**Operational Readiness Clearance (Non-beam operation)  
Liquid Argon Purification Demonstrator  
4 Dec 2021**

AUTHORIZATION TO RESUME UNATTENDED OPERATION OF LAPD IN PCA

From Leo Bellantoni

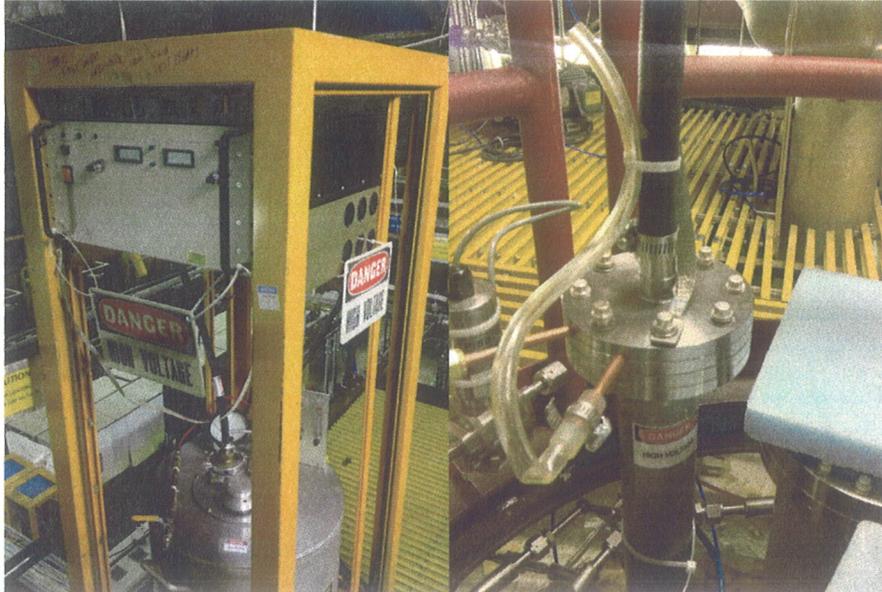
1. The DC and AC power wiring inside of the CCU chassis, which is a custom-built chassis, is not clear from the schematic and description. Therefore, I will need to physically look inside the chassis to examine the safety grounding and power wiring details. Also, the schematic needs to be updated/completed so as to include this information.

*One spare CCU chassis is at the Proton Pole Building (PPB) ready for inspection. We also updated the documentation for the CCU chassis:*

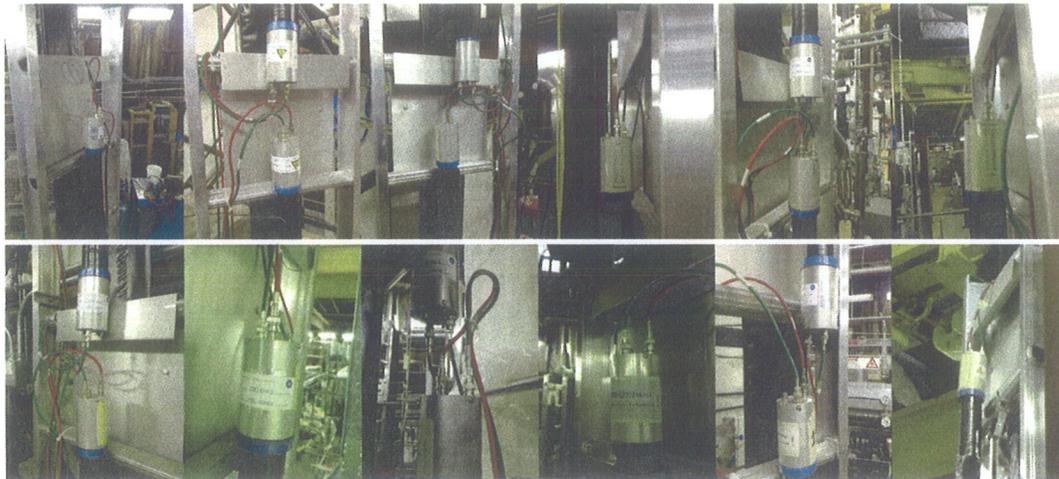
2. The power cords for the two scaler chassis, located within the Long Bo Counter rack, need to be strain relieved so that the weight of the cord does not pull on and stress the connector contacts.

*The power cords are strain-relieved.*
